PSLTR-00-0057

Dresden Nuclear Power Station, Units 2 and 3  
Facility Operating License Nos. DPR-19 and DPR-25  
NRC Docket Nos. 50-237 and 50-249

Subject: Request for an Amendment to Technical Specifications Section 3 /4.6.K, "Primary System Boundary" and Section 3 /4.12.C "Special Test Exceptions" and Request for Exemption from 10CFR 50.60, "Acceptance criteria for fracture prevention measures for lightwater nuclear power reactors for normal operation."

FIGURE 3.6.K-3

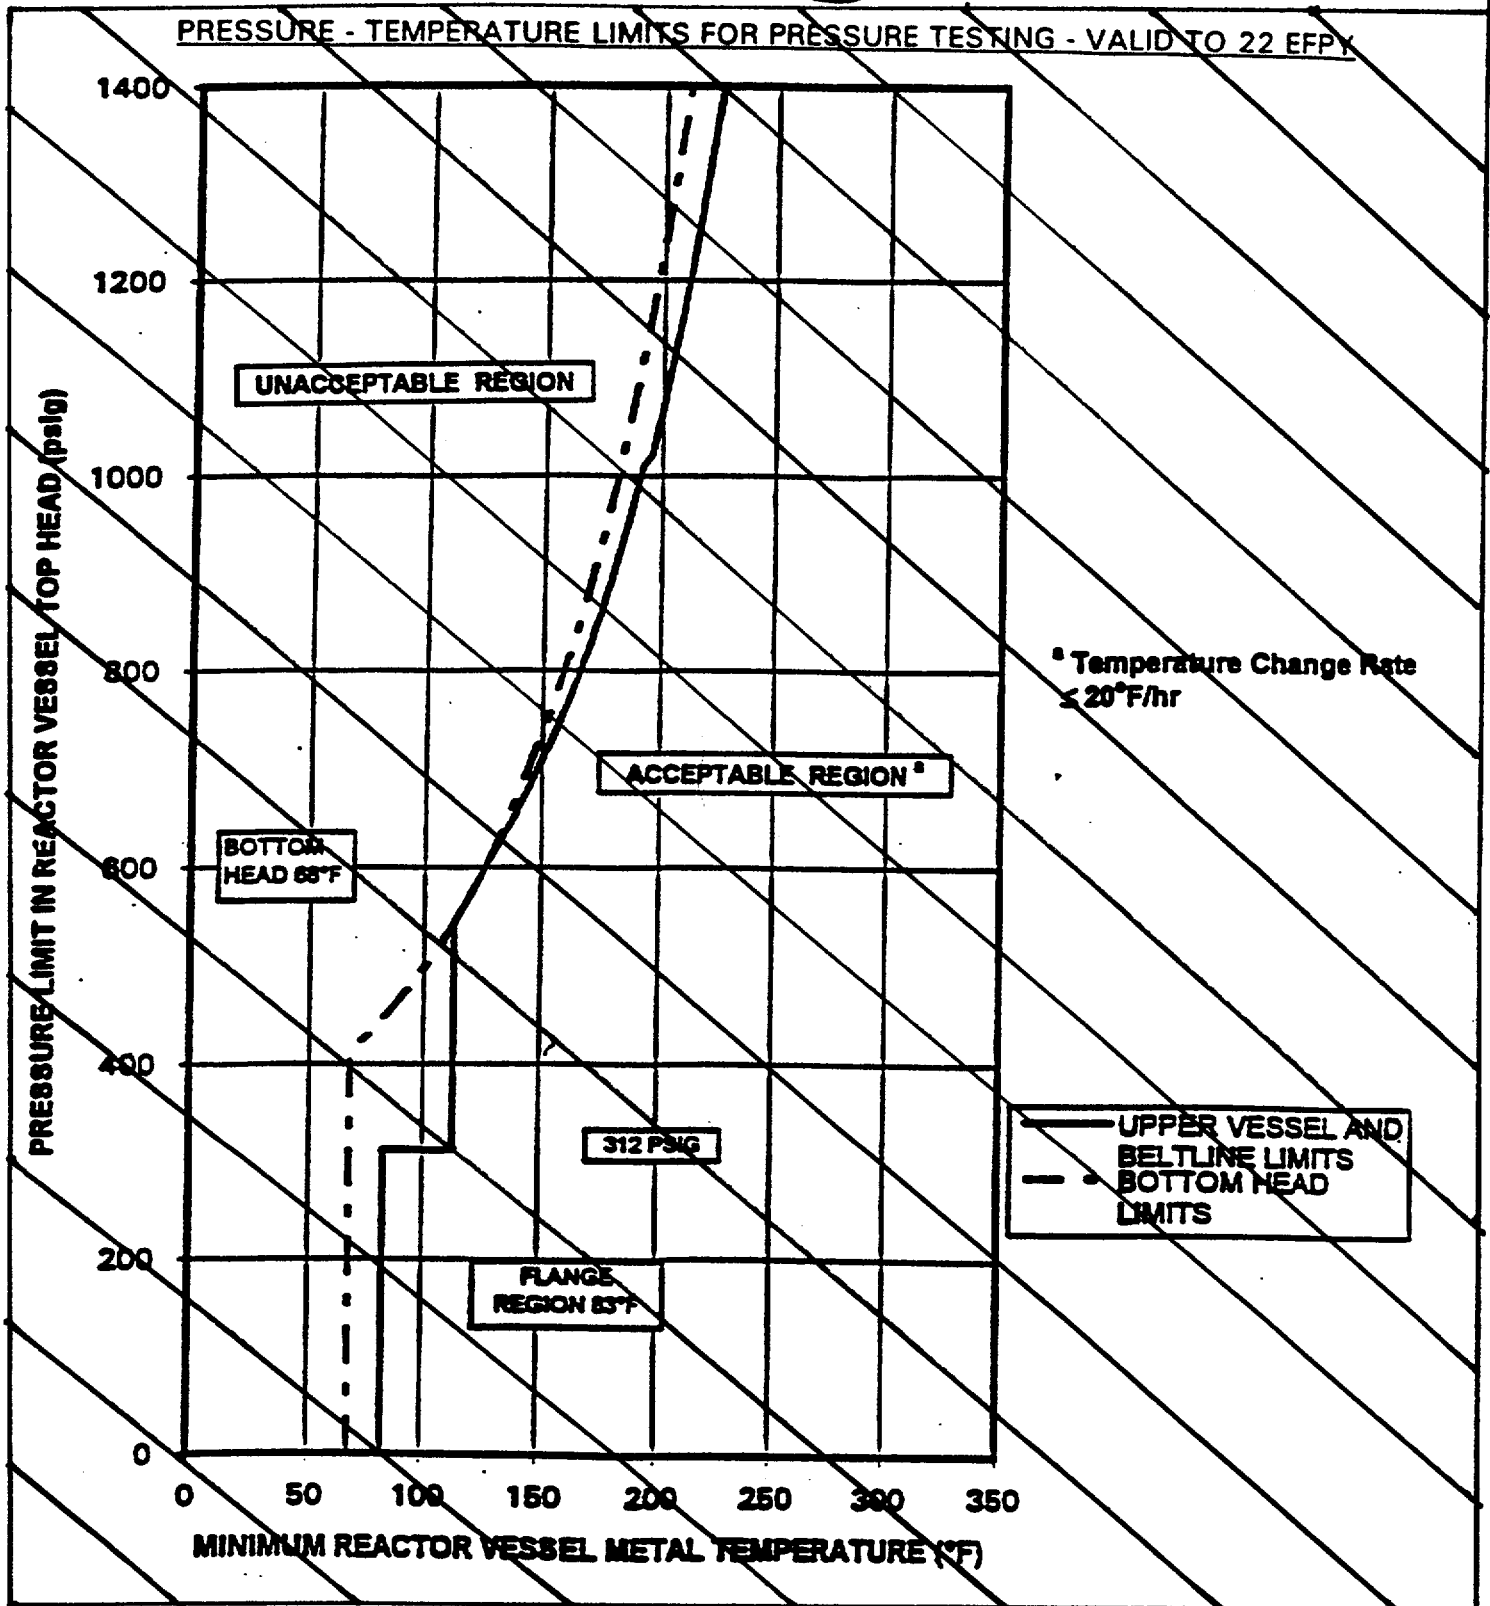
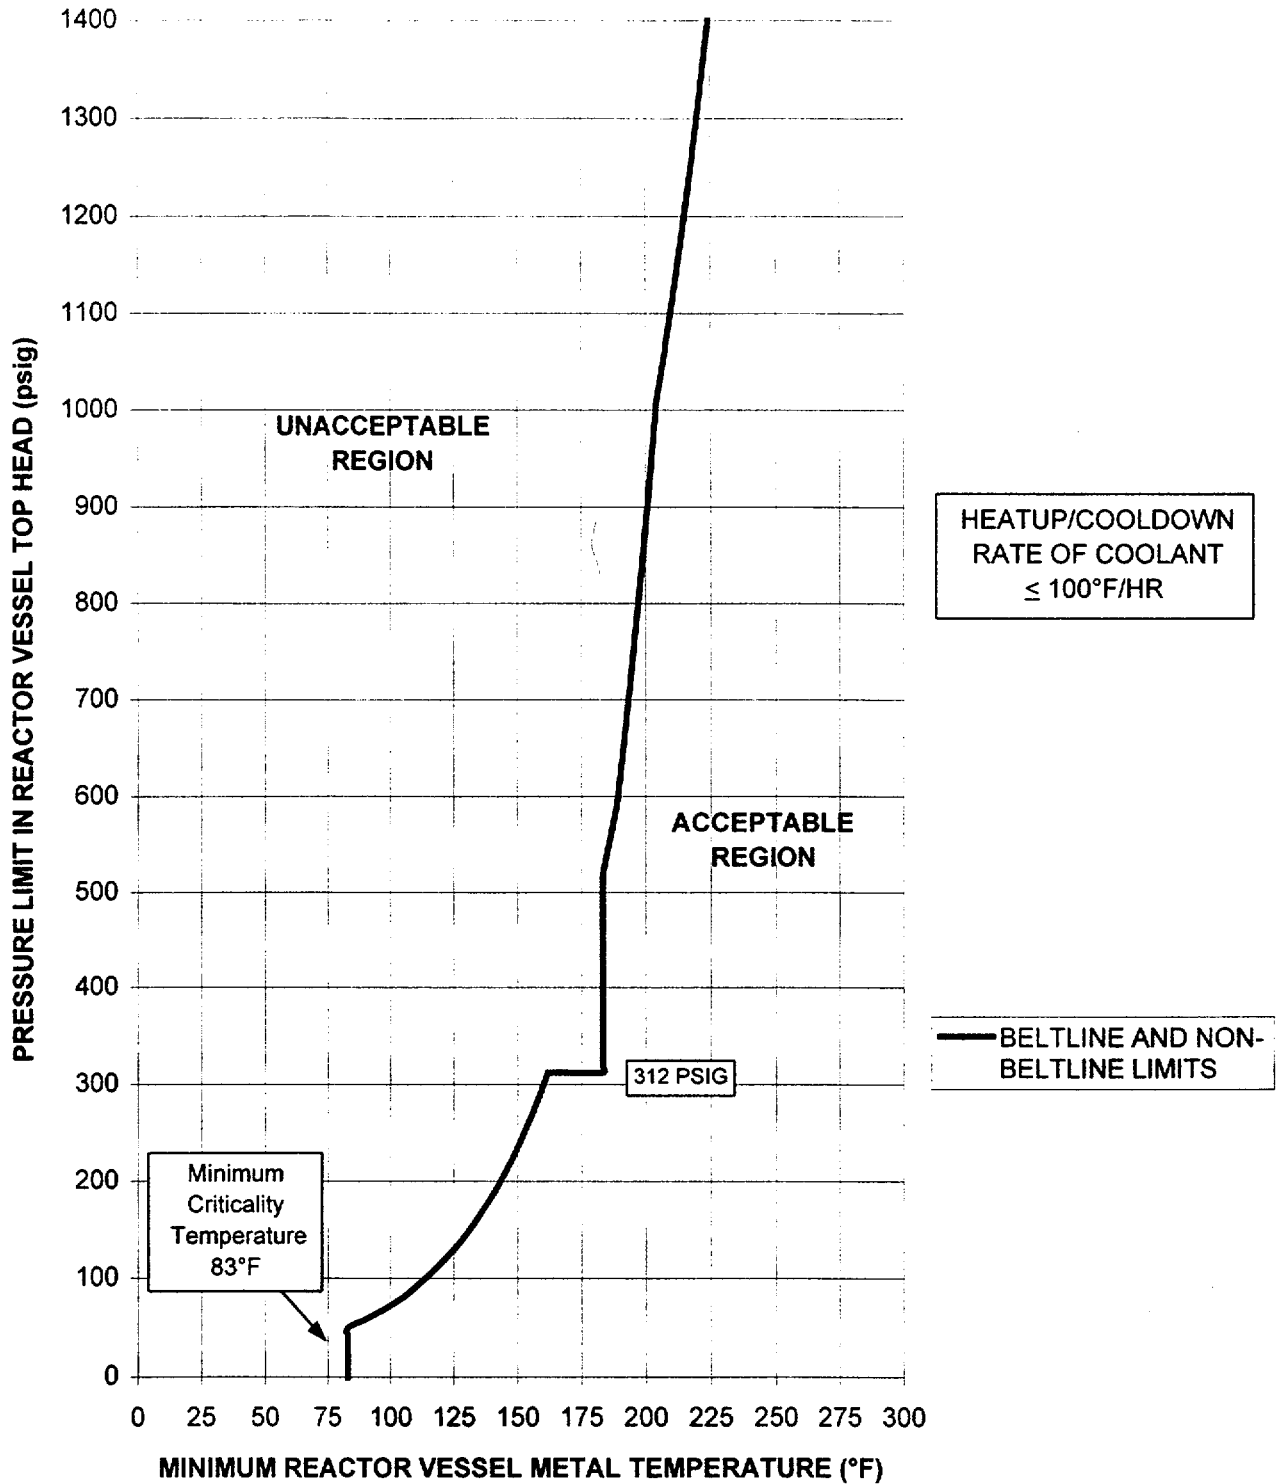
The proposed changes revise TS Figures 3.6.K-1 through 3.6.K-5, and delete the Special Test Exception for Inservice Leak and Hydrostatic testing operation. The proposed TS Figures 3.6.K-1 through 3.6.K-3 are bounding P-T curves for Unit 2 and Unit 3 RPVs.

3. Nuclear Heatup and Cooldown:
  - a. The reactor vessel metal temperature and pressure shall be maintained within the Acceptable Region as shown on Figure 3.6.K-~~6~~<sup>3</sup>, and
  - b. The rate of change of the primary system coolant temperature shall be  $\leq 100^{\circ}\text{F}$  per hour.
4. The reactor vessel flange and head flange temperature  $\geq 83^{\circ}\text{F}$  when reactor vessel head bolting studs are under tension.

INSERT Figure 3.6.K-3

PRESSURE - TEMPERATURE LIMITS FOR CRITICAL CORE OPERATIONS - VALID TO 32 EFY

FIGURE 3.6.K-4

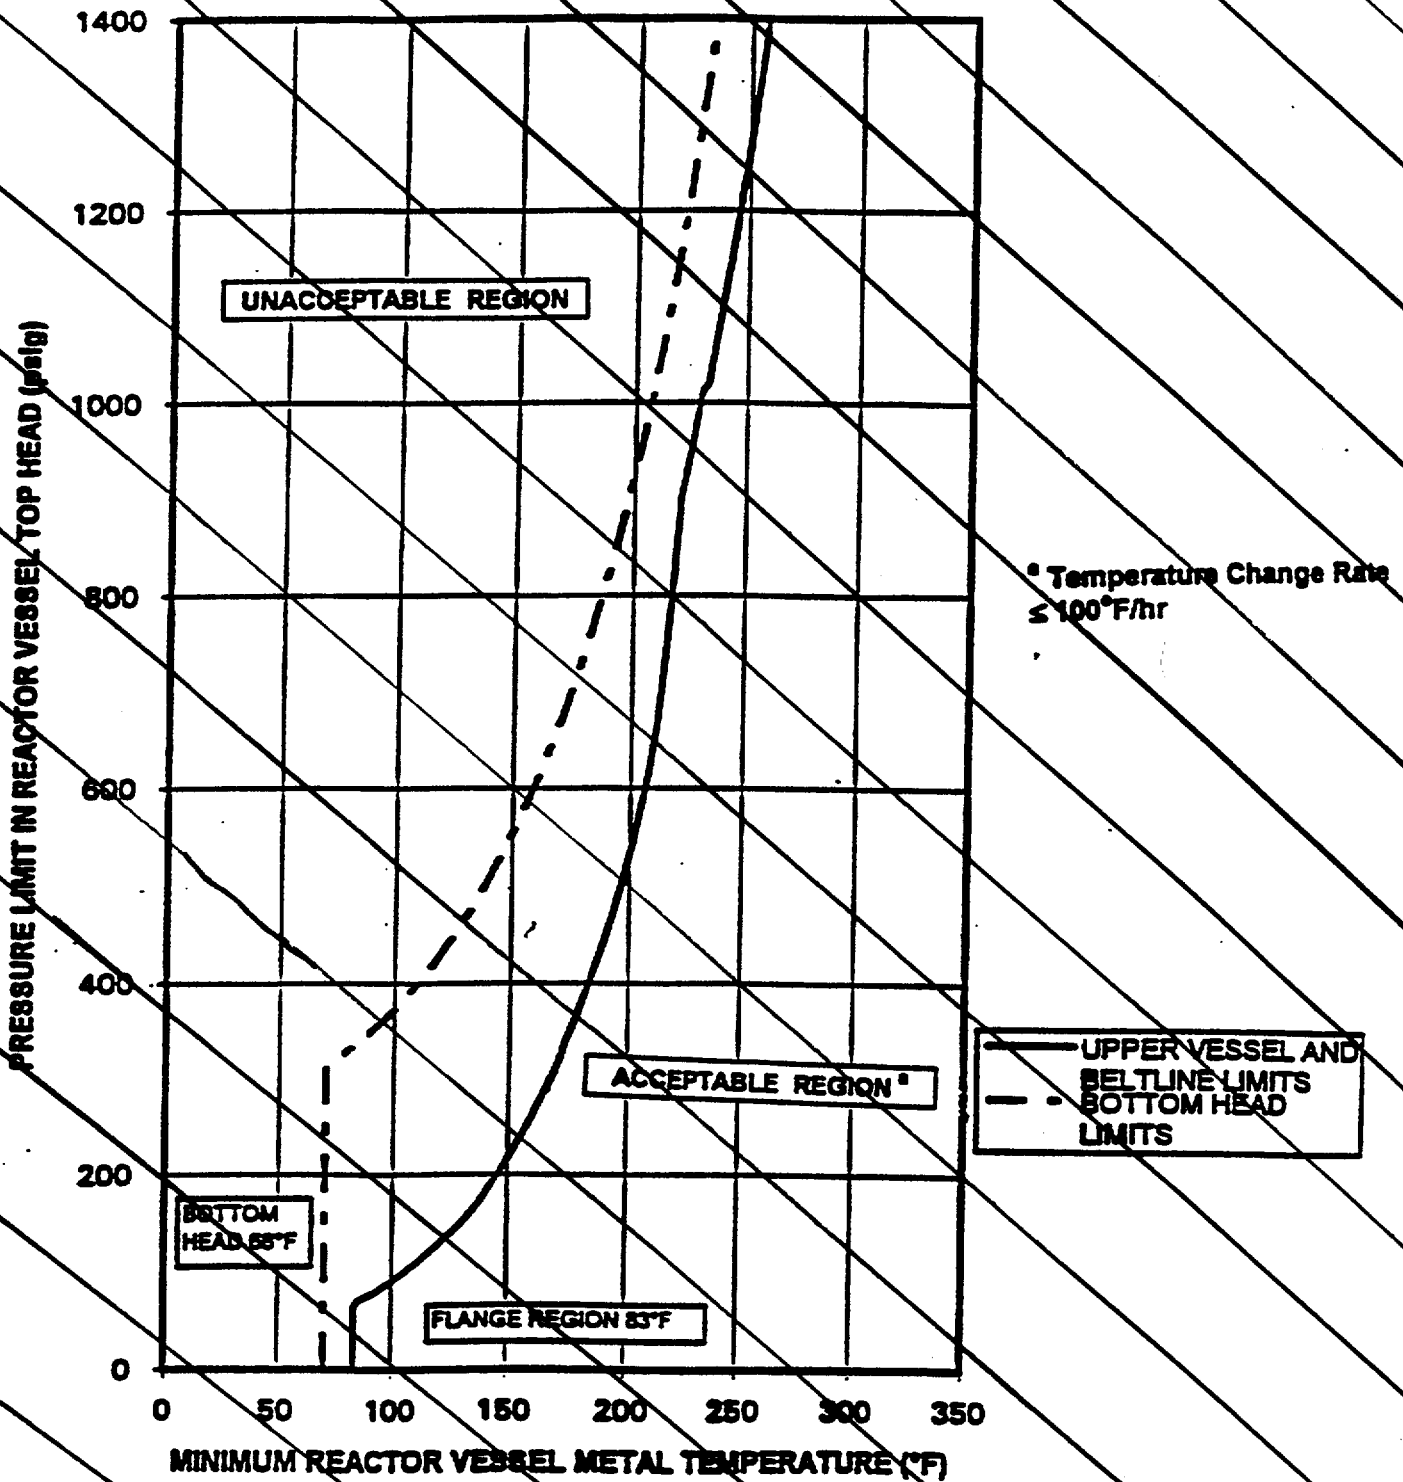
The pressure-temperature limit lines are shown, for operating conditions; Pressure Testing, Figure 3.6.K-1 ~~(through 3.6.K-3)~~, Non-Nuclear Heatup/Cooldown, Figure 3.6.K-4, and Core Critical Operation Figure 3.6.K-5. The curves have been established to be in conformance with Appendix G to 10 CFR Part 50 and Regulatory Guide 1.99 Revision 2, and take into account the change in reference nil-ductility transition temperature ( $RT_{NDT}$ ) as a result of neutron embrittlement. The adjusted reference temperature (ART) of the limiting vessel material is used to account for irradiation effects.

Figure 3.6.K-4 applies during heatups with non-nuclear heat (e.g., recirculation pump heat) and during cooldowns when the reactor is not critical (e.g., following a scram). The curve provides the minimum reactor vessel metal temperatures based on the most limiting vessel stress. The maximum heatup/cool-down rate of 100°F/hour is applicable. <sup>2</sup>

FIGURE 3.6.K-5

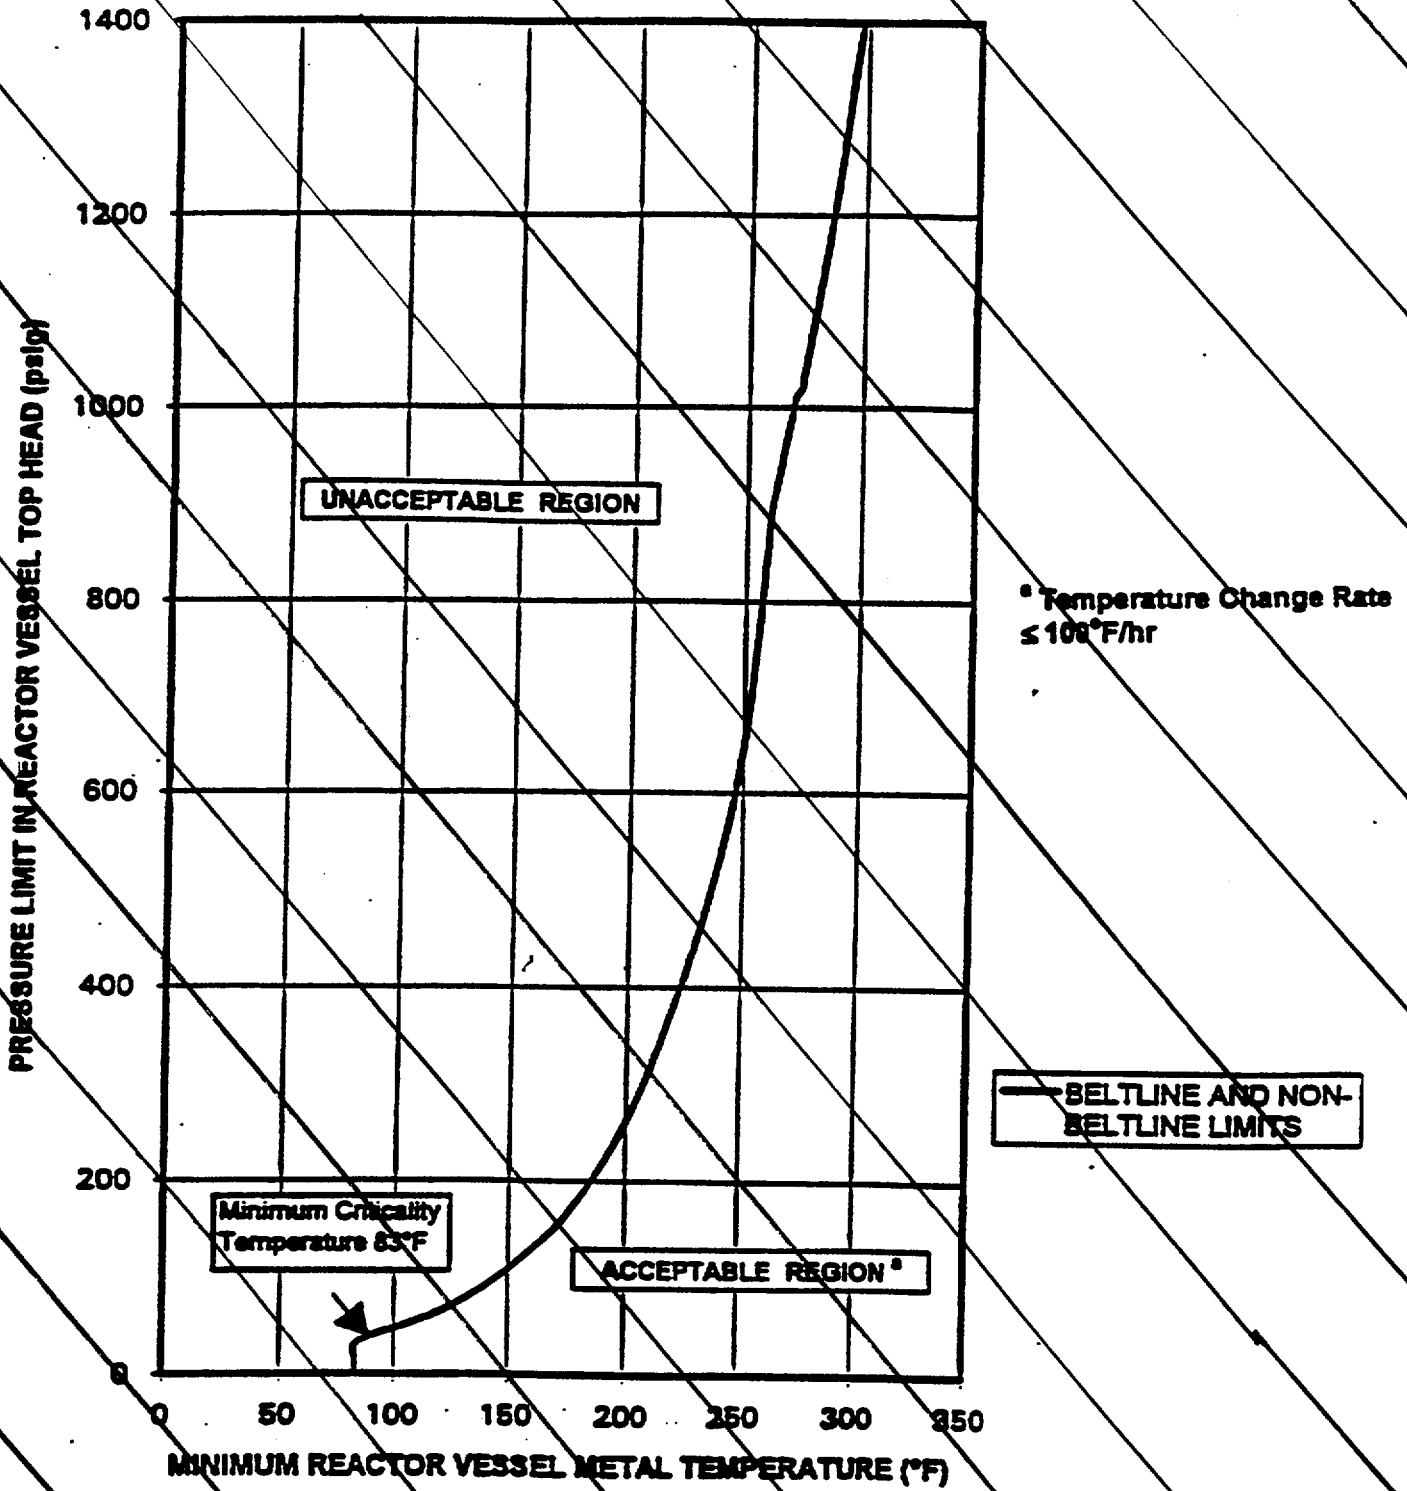
The core critical operation curve shown in Figure 3.6.K-5, is generated in accordance with 10CFR Part 50 Appendix G which requires core critical pressure-temperature limits to be 40°F above any pressure testing or non-nuclear heatup/cool-down limits. Since Figure 3.6.K-4 is more limiting, Figure 3.6.K-5 is Figure 3.6.K-4 plus 40°F. The maximum heatup/cool-down rate of 100°F/hour is applicable. <sup>3</sup>
